CONVAIR
A Division of General Dynamics Corporation
San Diego, California

COMMERCIAL CHANGE PROPOSAL

SPEC NO: ZD-22-002

MODEL: (880) 22-1

FIGURE 3.1-2

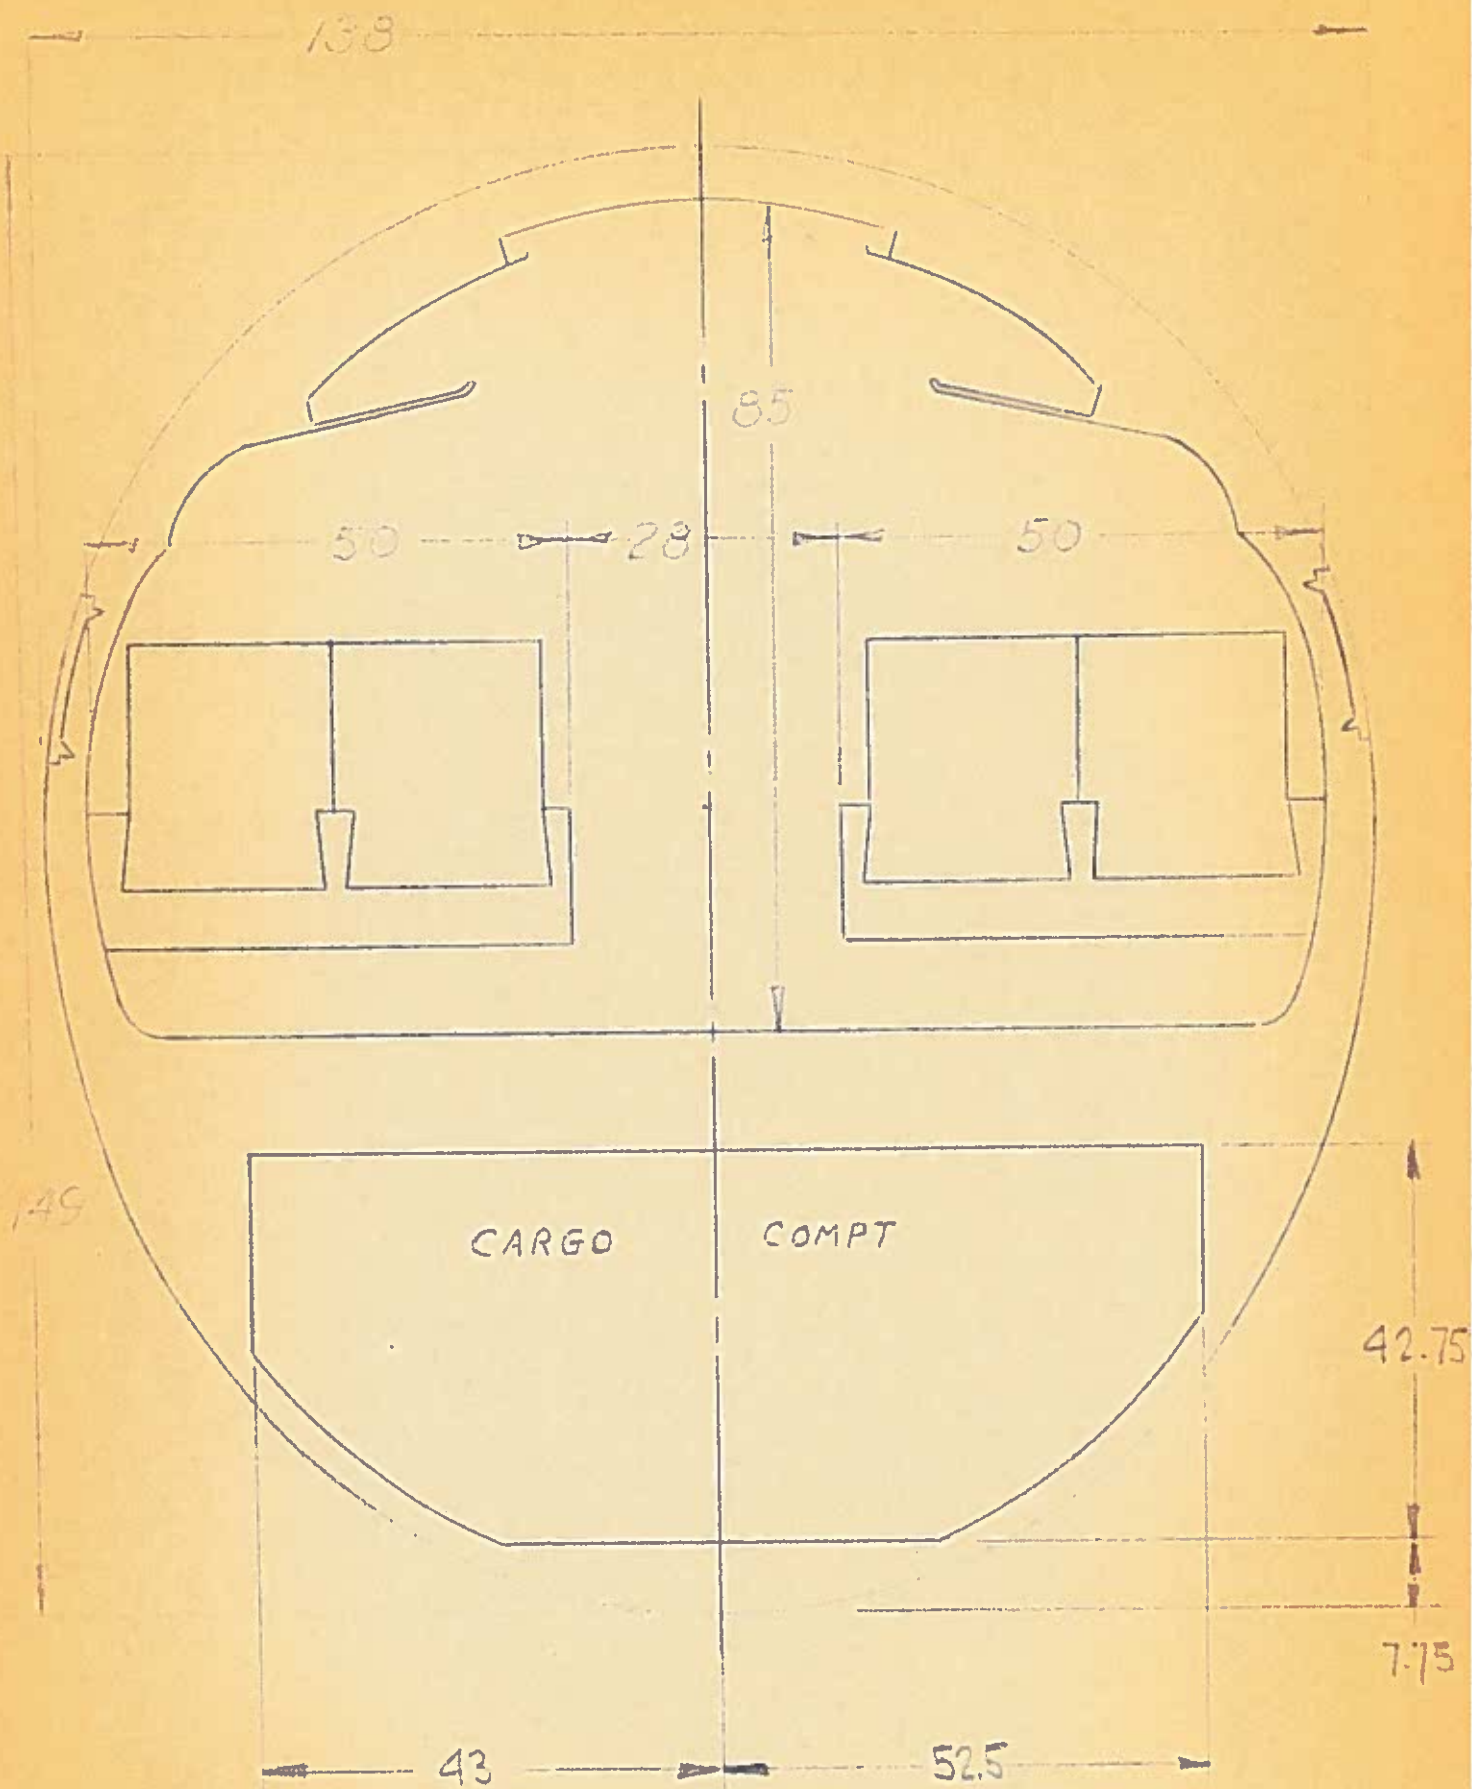
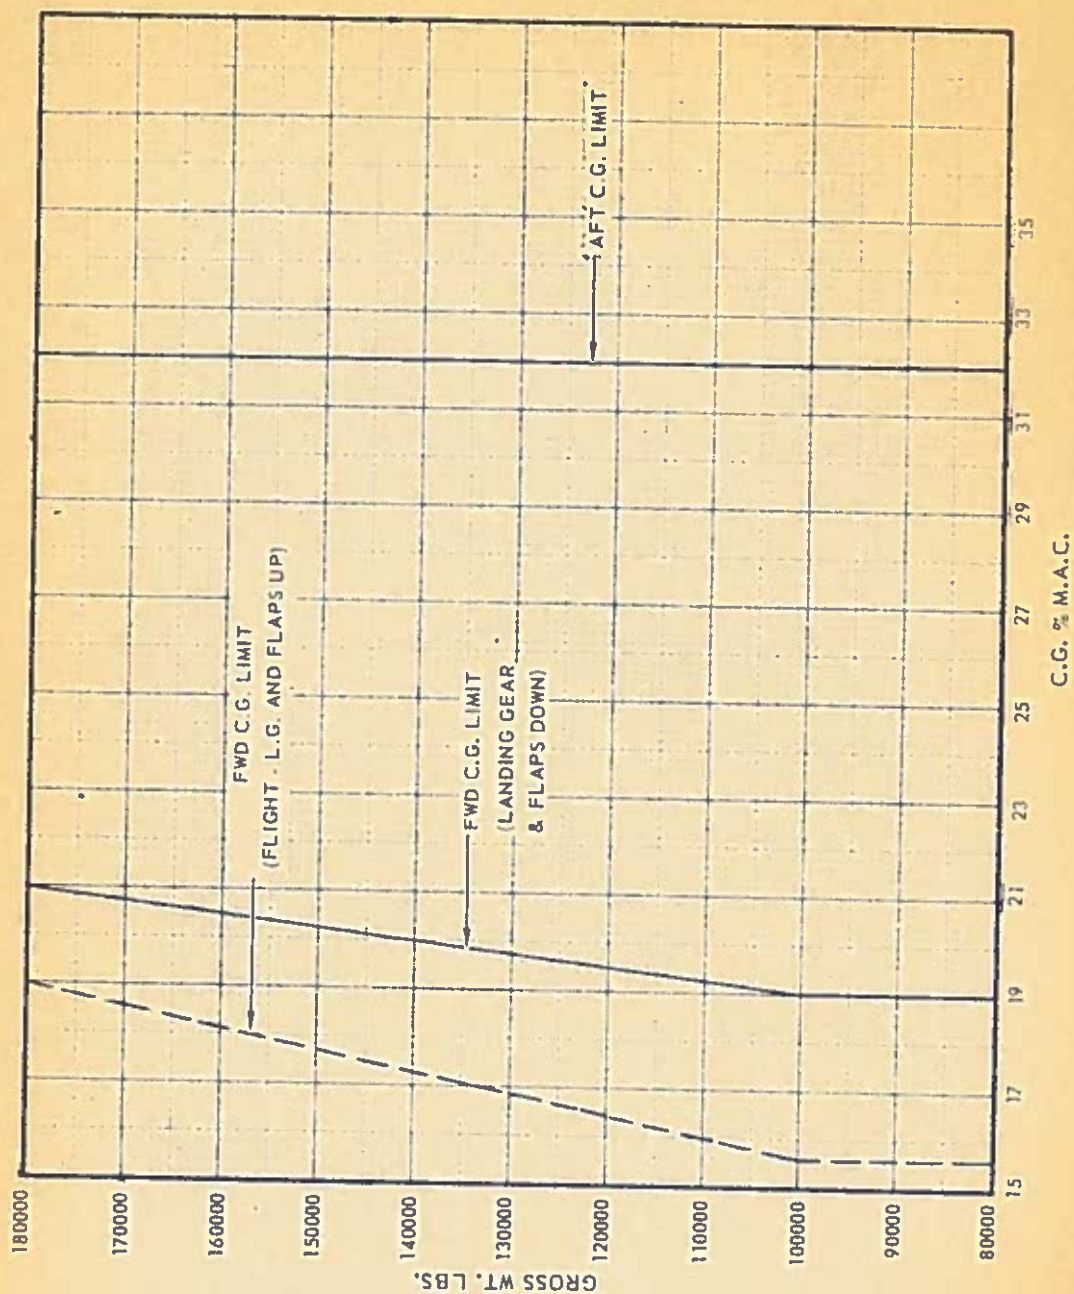
Figure 3.1-2 C.G. DESIGN LIMITS

Replace present figure in Specification with Enclosure (C)
